# Product Change Notification

**Change Notification #:** 118659-01  
**Change Title:** Select Intel® Ethernet Network Adapter OCP3.0 I350-T4, OEM Gen, PCN 118659-01, Product Design, Label Label and Internal Lock Faceplate Update  
**Reason for Revision:** Material depletion  
**Date of Publication:** February 11, 2022

New Painter Flat Faceplate

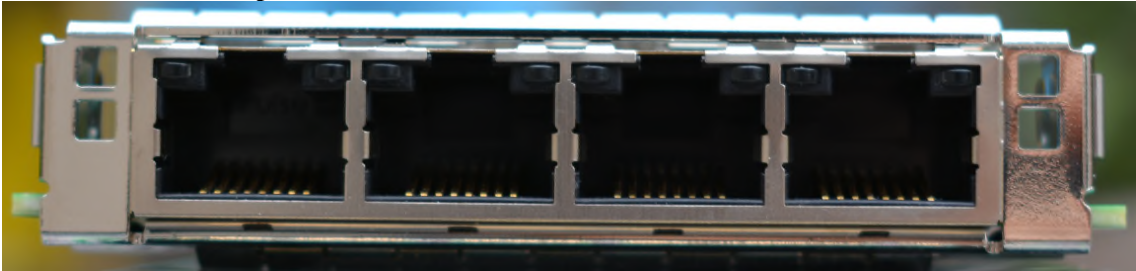
1. ~~The Intel(R) Ethernet Network Adapter OCP3.0 I350 T4 will be updated to use an enhanced OCP3.0 faceplate. The updated faceplate has been enhanced to ensure all mechanical dimensions have tighter tolerances to meet OCP3.0 mechanical Critical to Function requirements. Implementation of the new faceplate will be pushed out to September 2022.~~
